Application for Works Approval Amendment

Works Approval Number	W6618/2021/1
Works Approval Holder	Talison Lithium Australia Pty Ltd
ACN	139 401 308
File Number	DER2021/000628
Premises	Talison Lithium Mine Maranup Ford Road Part of mine tenements M01/6 and M01/7 As defined by the premises maps in Schedule 1 As defined by the Premises map attached to the Revised Works Approval
Date of Report	1 September 2023
Decision	Revised works approval granted

On 5 July 2023, the works approval holder submitted an application to the department to amend works approval W6618/2021/1 under section 59 and 59B of the *Environmental Protection Act 1986* (EP Act). The proposed amendment is to modify a portion of the liner for tailings storage facility 4 (TSF4) cell 1, to bituminous geomembrane (BGM). Construction progress for the clay liner, originally authorised, has been impacted by winter rains. The clay liner will not be completed in time for TSF4 to begin accepting tailings, given the current tailings storage facility 2 (TSF2) will reach capacity in September 2023. Specifically, BGM will be installed across approximately 12.8 hectares (ha) of the ~80 ha floor of cell 1 (~16% of floor area) in the

Figure 3 Sensitive receptors downstream of TSF4

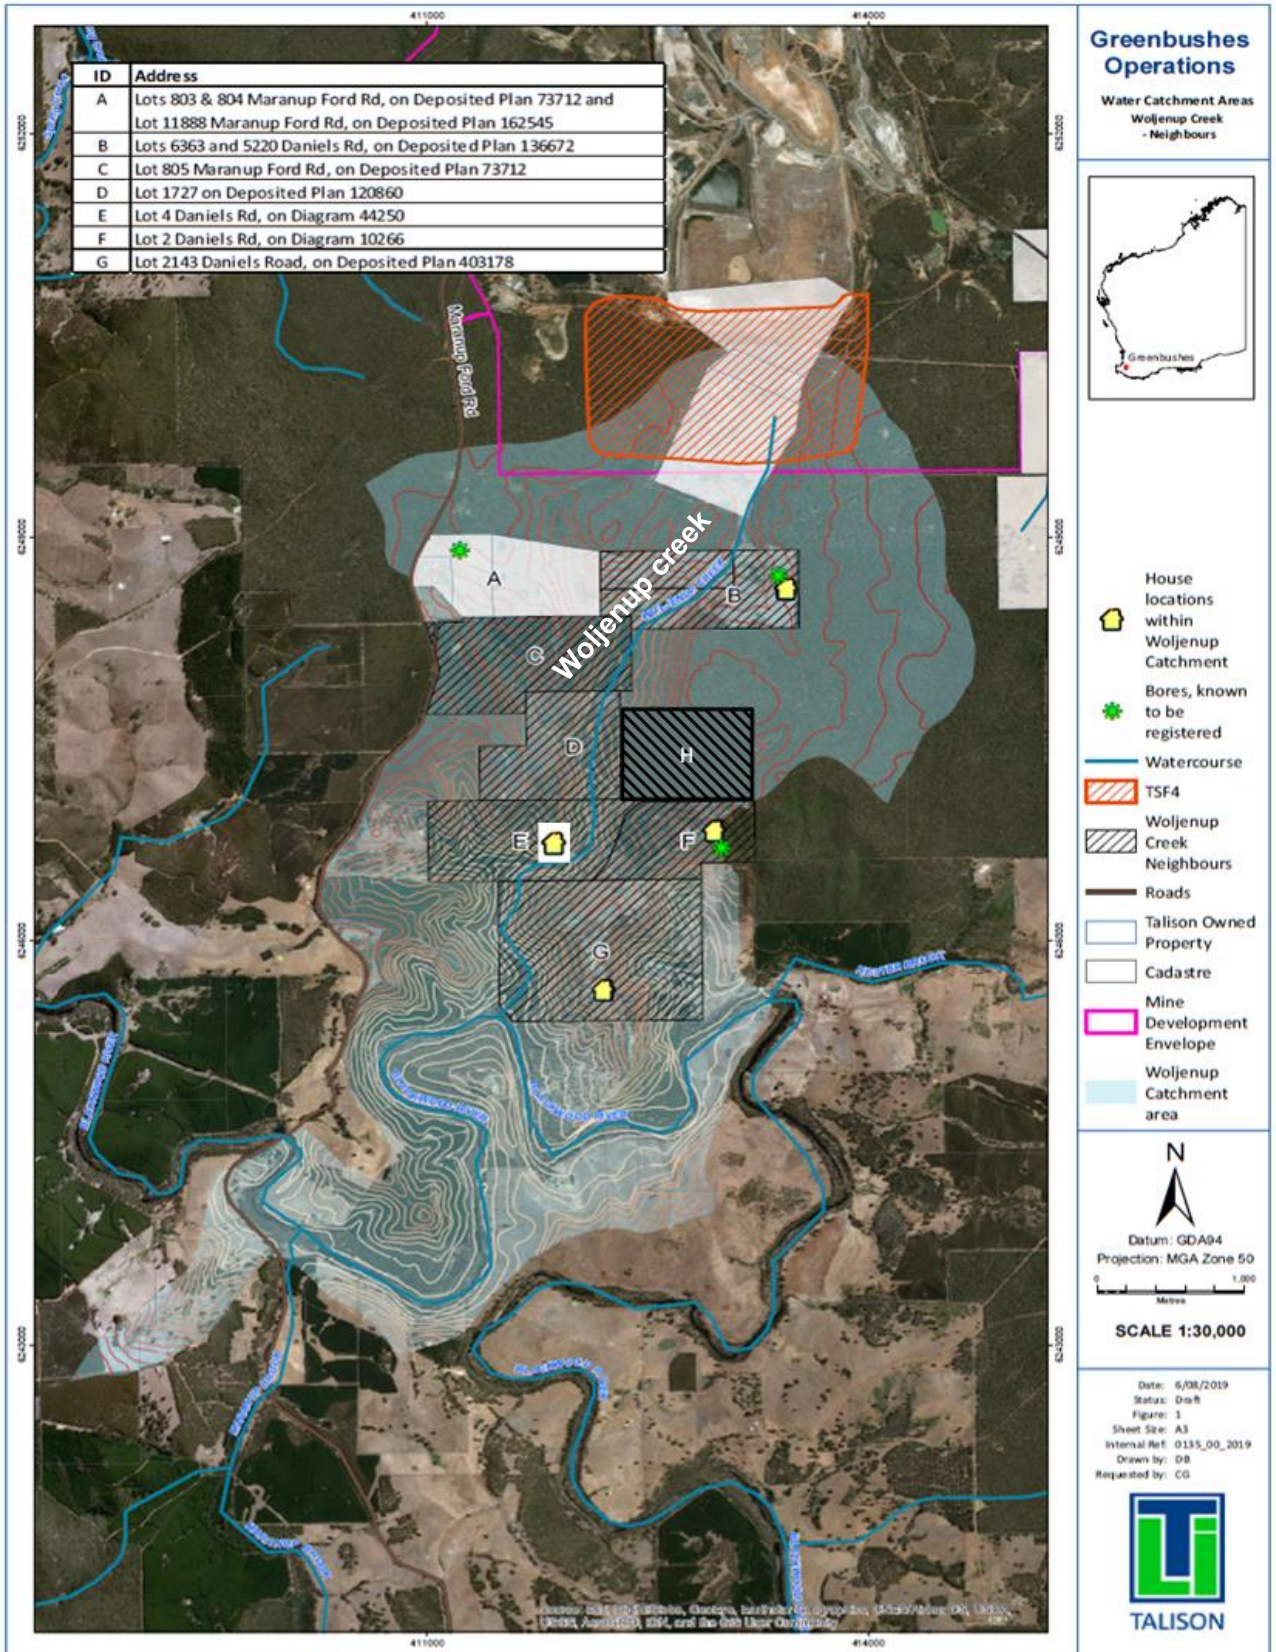
(including swimming), aquaculture activities, irrigation for crops and stock water.
Environmental receptors	Distance from prescribed activity
Blackwood River and tributaries, including Woljenup creek	Woljenup creek is immediately south and down-gradient of TSF4 (Figure 3)
Cowan Brook, Norilup Dam and Norilup Brook (water quality and ecology)	At the western edge of the premises boundary (offsite). Seepage from Cowan Brook Dam flows into Cowan Brook and into Norilup dam. (Figure 6, Appendix 1)
Nearby native vegetation	Immediately adjacent to TSF4
<u>DBCA Legislated Tenure</u> Greenbushes State Forest	A proposal for expansion activities (including TSF4) was approved under Part IV of the Act for which Ministerial Statement MS 1111 was granted on 19 August 2019.
Threatened/priority flora and fauna	Receptors addressed under ministerial statement MS 1111 are not assessed in this decision report and are not duplicated as conditions in the works approval.

Figure 5: TSF4 cell 1 starter embankment BGM tie-in detail

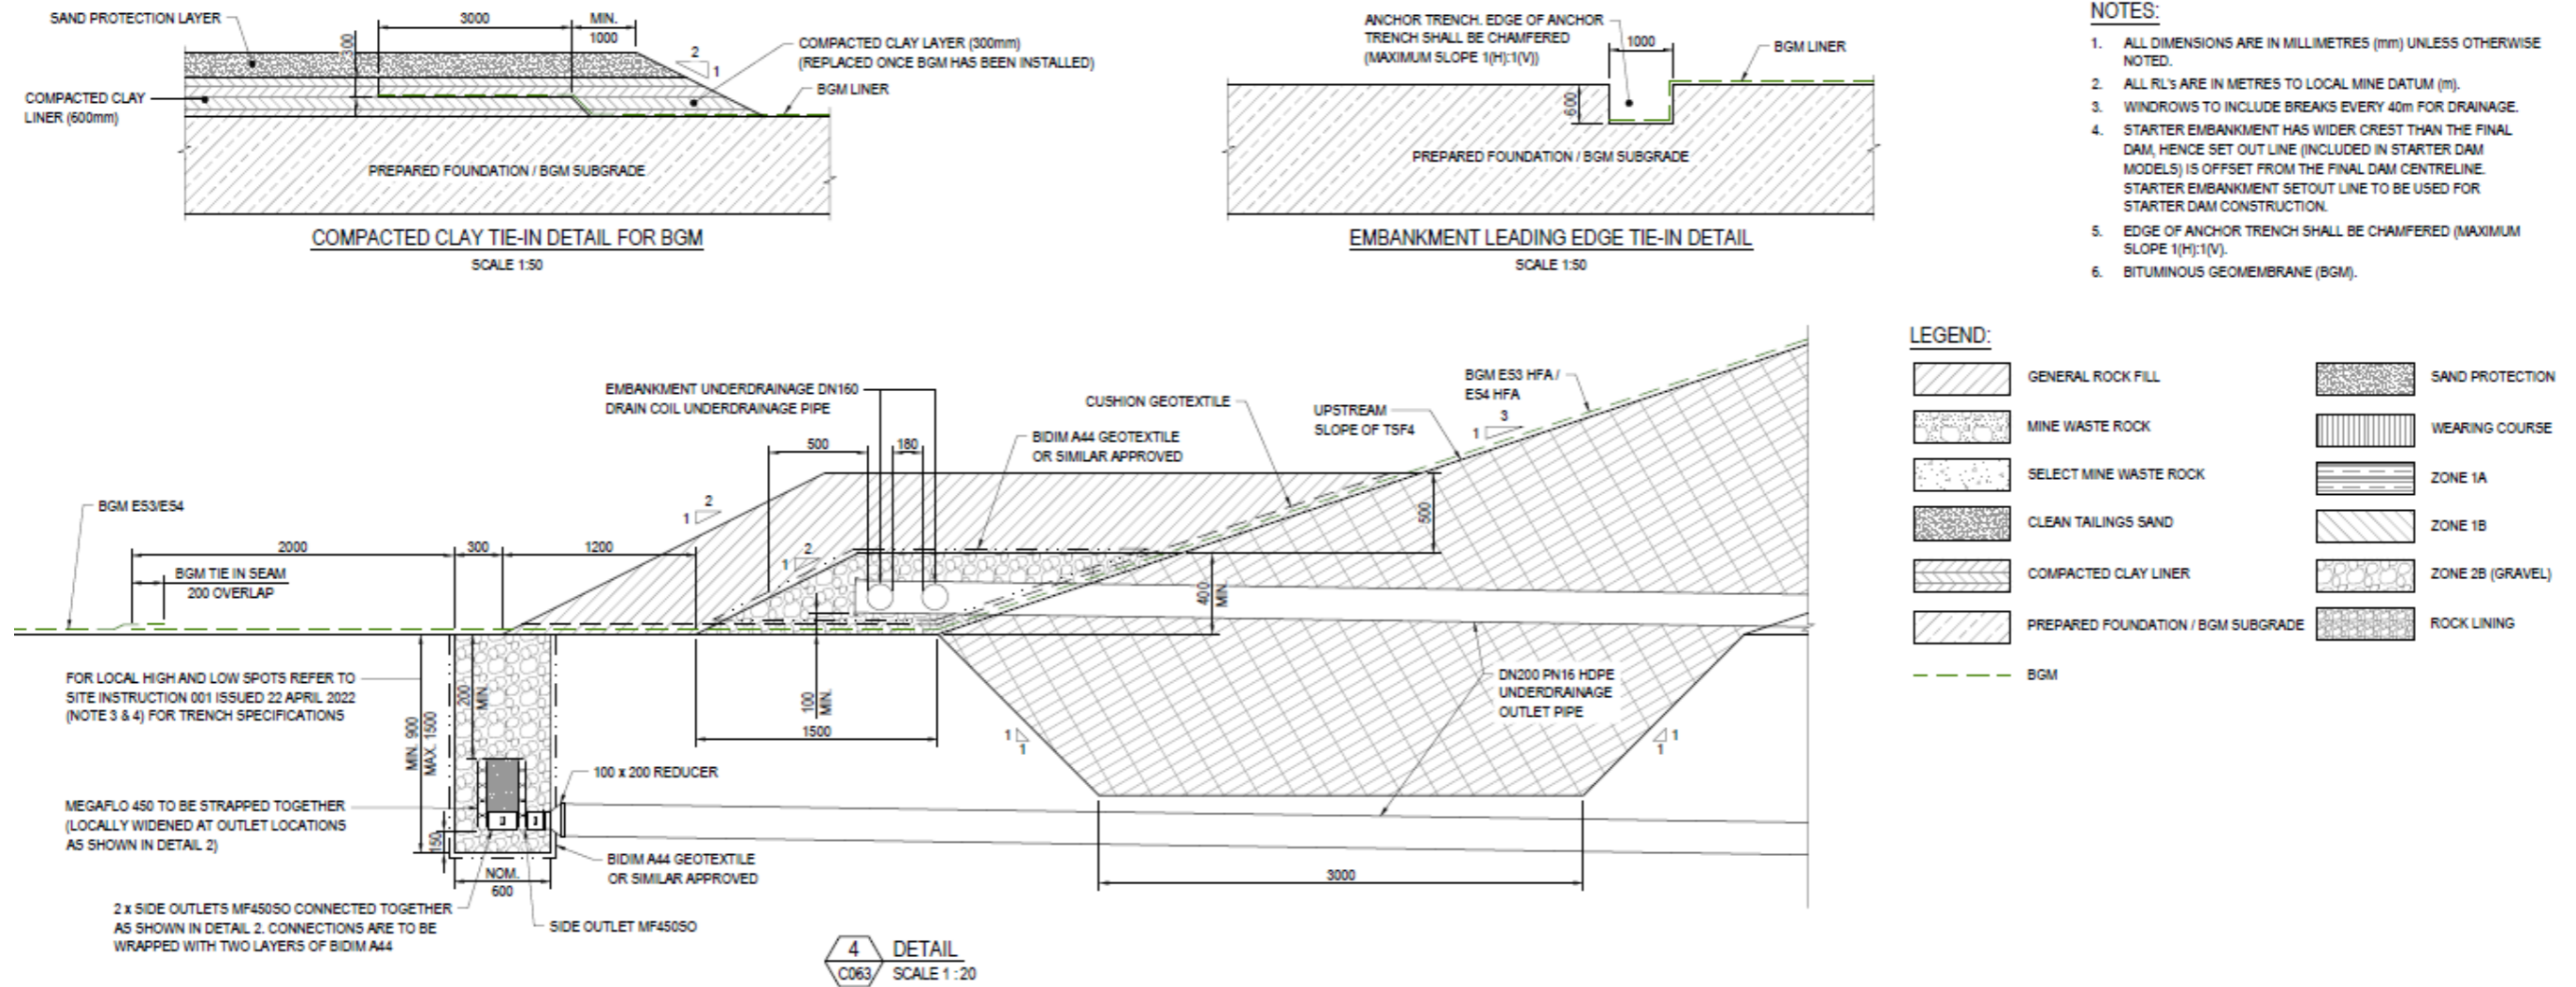
<ul style="list-style-type: none"> Increased seepage along joints between BGM and clay liner 		<ul style="list-style-type: none"> The BGM will be tied into the placed clay liner (Figure 5, Appendix 1) by removing the 200 mm sand cover and excavating a 3.0 m wide and 0.3 m deep tie-in trench into the clay liner. The BGM will be placed in the tie-in trench and the trench backfilled with the excavated clay and compacted. The leading edges of the BGM will be tied into the embankments in a 1.0 m wide and 0.6 m deep anchor trench.

Operation of TSF4 cell 1 with a liner comprising 16% BGM and 84% clay rather than 100% clay: <ul style="list-style-type: none">Increased seepage along joints between		Migration of contaminated groundwater off-site causing adverse impacts to ecosystem health and human health	Blackwood River and tributaries, including Woljenup Creek		Nearby native vegetation	C = Moderate L = Unlikely Medium Risk	Y	Condition 1 – modified to include minimum BGM construction requirements – tie in detail

Figure 6 On premises water storage and off-site surface water

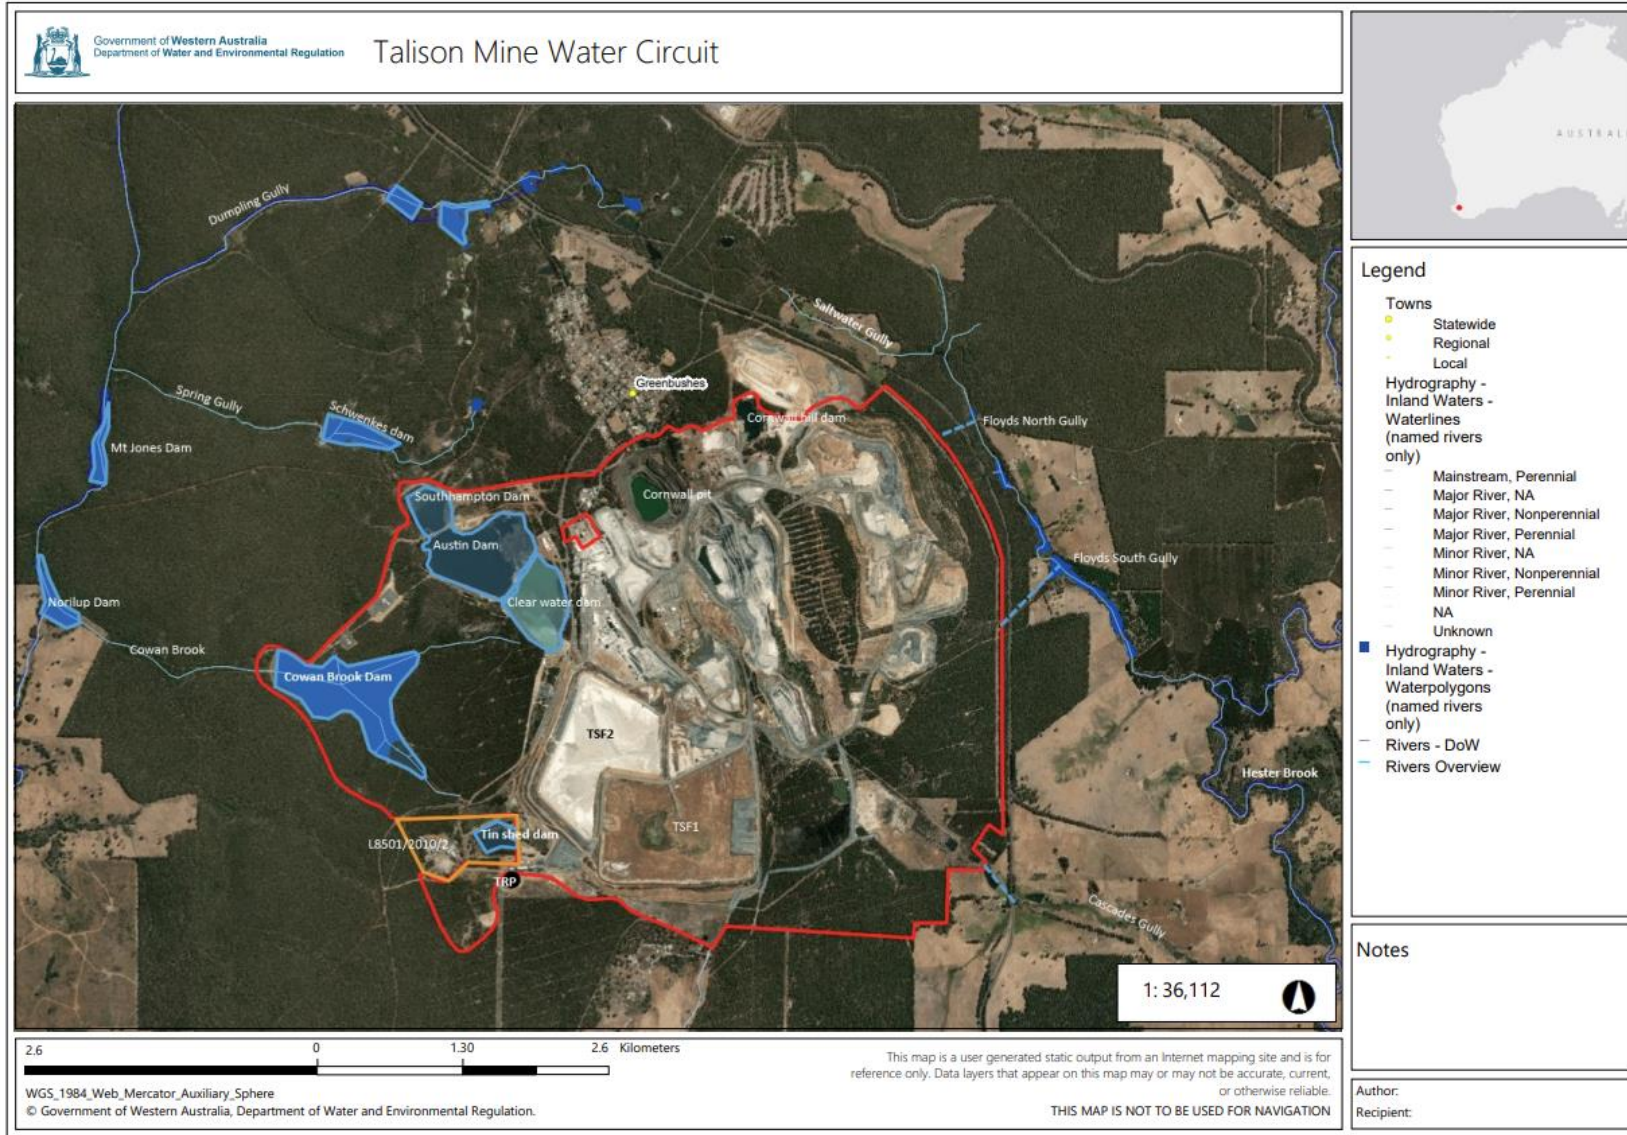
The mine water circuit is made up of several hydraulically connected unlined earthen dams containing process water; namely Clear Water Dam (primary dirty water dam), Austin Dam, Southampton Dam and Cowan Brook Dam (see Figure 6, Appendix 1). Process water generated at the premises is contaminated with metals and metalloids including lithium, arsenic, manganese and nickel. Some of this water is reused in the process, however water from the
